RE: **26-DR-2024**
HonorHealth Shea Parking Garage
K4998 (Key Code)

Planning & Development Services has completed review of the above referenced development application submitted (payment accepted) on **9/25/24**. The following comments represent issues or deficiencies identified by the review team and are intended to provide you with guidance for compliance with city codes, policies, and guidelines as categorized below:

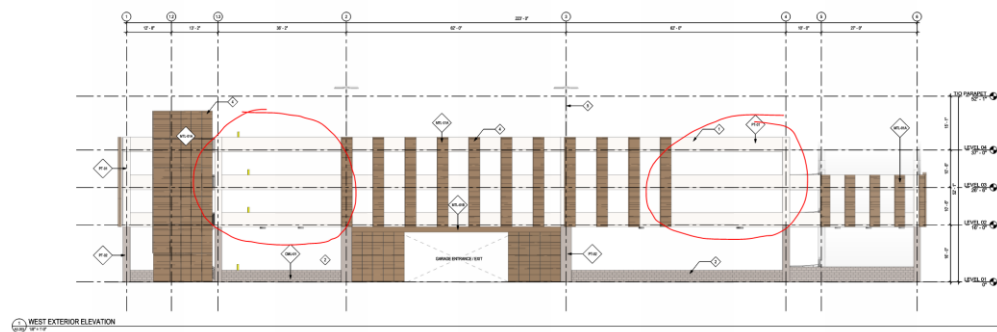
9. Please provide a building transition elevation plan from 90th Street consistent with the stepback requirements of the Development Plan approved under case 1-ZN-2009 (a maximum 69-feet of allowable height at the 40-foot setback, stepping 1:3 to a maximum 120' of allowable height). Please consider addressing with resubmittal.
10. Please show the full extent of the garage proposal with the "future" 5th level included on the project plans. It appears only 4 levels are shown; however, the intent to add a 5th level in the future should be presented to the DRB to ensure the design standards can still be achieved. Please address with resubmittal.
11. Please update the proposal to include more vertical panel elements on the western façade. The western

façade is the most visible orientation of the building and therefore should reflect a higher level of design with a more complete appearance. Additionally, the exposed ceiling-mounted light fixtures at each level cannot be fully concealed from the street level, as proposed. The additional panels would further help to mitigate the amount of unconcealed light from the street level. Please update with resubmittal.

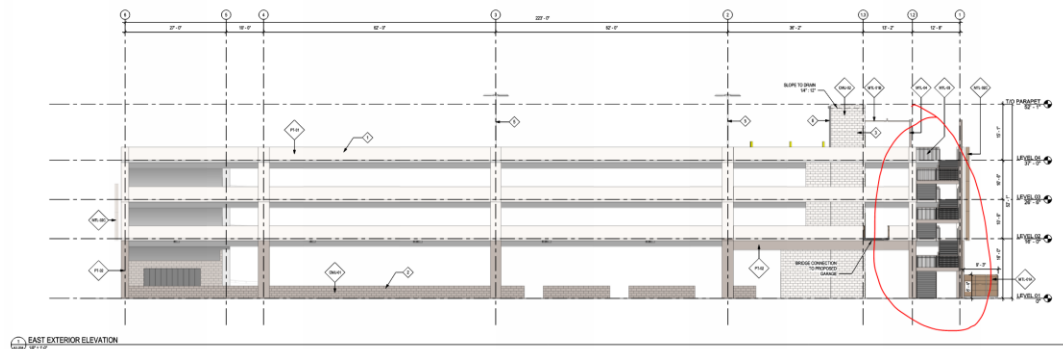
12. Please consider utilizing a more opaque enclosure for the western stairwell's western façade along the 90th Street frontage, or demonstrate that the intended design will add an enhanced appearance to the stairwell for the perforated parasoleil stairwell enclosure -i.e. solar analysis/shade study. Typically: stairwells, elevators, mechanical enclosures, etc. should not be located/orientated closest towards the street frontage.
13. Please consider adding an enclosure to the eastern stairwells' eastern façade as the proposed design reflects an unfinished appearance inconsistent with the City's design guidelines.

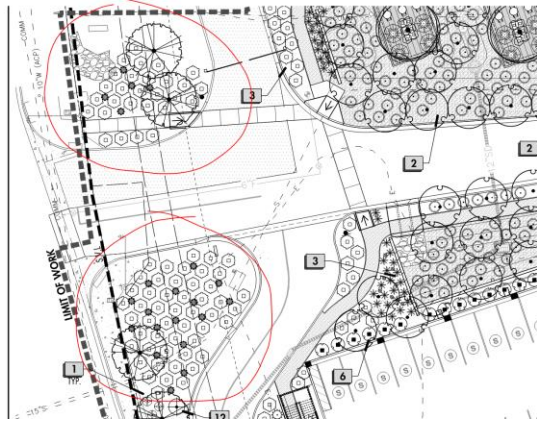
22. Please confirm that the proposed amenities are consistent with the site standards approved under the Development Plan for case 1-ZN-2009 by including details that closely match the Development Plan. Please include more info on the site details plan. See excerpt image below from the DP:

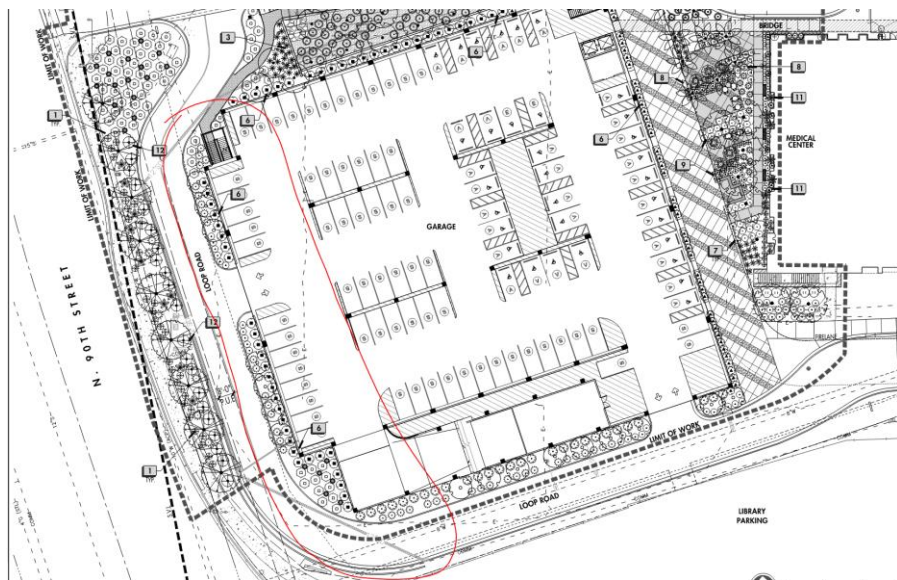
28. Please ensure that the landscape plan matches the proposed renderings. It appears some trees are missing along the building's western/southwestern façade on the landscape plan. Please revise with resubmittal.

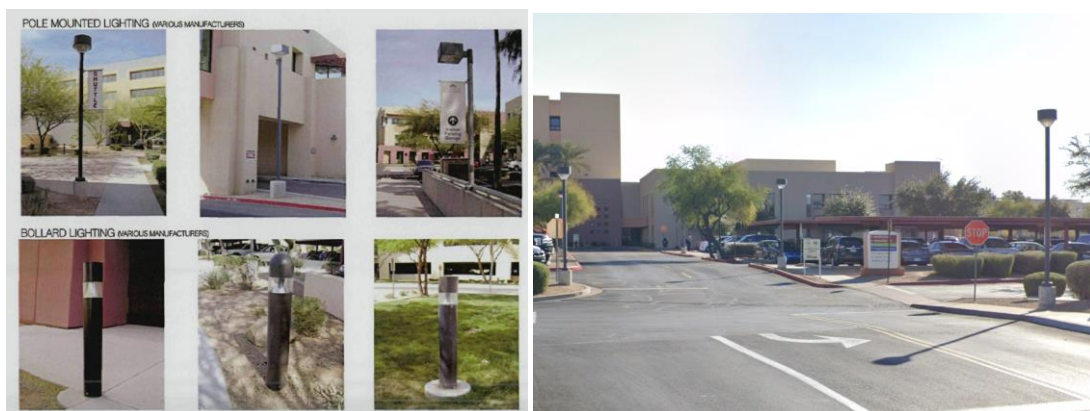
35. Light fixtures should provide a consistent visual aesthetic with the existing lighting fixtures, per the Development Plan approved under case 1-ZN-2009. It appears fixtures 'SL1' and 'SL2' do not provide a consistent visual aesthetic with the existing pole mounted lights on the site. Please indicate if all future pole mounted lights on the overall HonorHealth site will be consistent with the proposed D Series LED pole lights or revise the lighting plan to maintain continuity with the existing lighting poles on the site.
